# Iowa Department of Transportation

## MINUTES OF IOWA D.O.T. SPECIFICATION COMMITTEE MEETING

April 8, 2010

Figure 1. Target Location

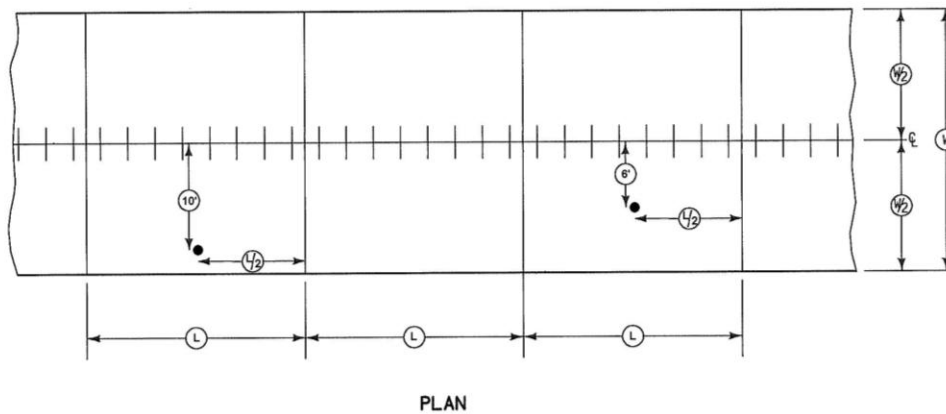
1. Divide the section longitudinally into 200 foot (50 m) long lots. One target will be located in each lot based on the spreadsheet selection (The targets should be placed half way between dowel baskets). See Figure 1. A minimum of ten targets will be tested. If a target location falls on a bridge or in an approach section, it will be eliminated.

<b>Iowa Department of Transportation</b>	REVISION	
	New	10-19-10
<b>STANDARD ROAD PLAN</b>	<b>PV-3</b>	
REVISIONS: New.	SHEET 1 of 2	
<i>Deanna Maifeld</i> <small>APPROVED BY DESIGN METHODS ENGINEER</small>		
<b>SAFETY EDGE</b>

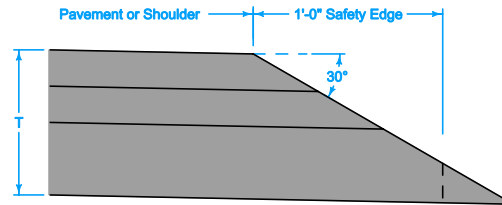
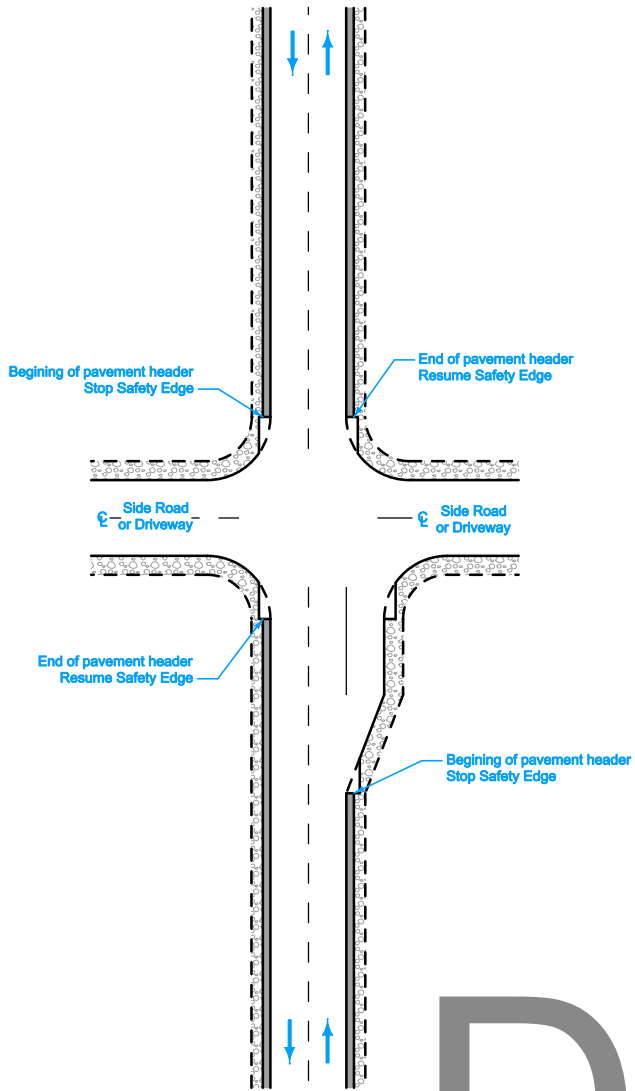
Attach a device to the paver screed to confine material at the end gate and extrude the asphalt material in a wedge shape meeting the requirements of the plan details. Maintain contact between the device and road shoulder surface; and allow automatic transition to cross roads, driveways, and obstructions. Use the device to constrain the asphalt head, reducing the area and increasing the density of the extruded profile. Use of a single plate strike off will not be allowed.

Modify paver screed to ensure the Safety Edge meets the final cross-section as detailed on the plans.
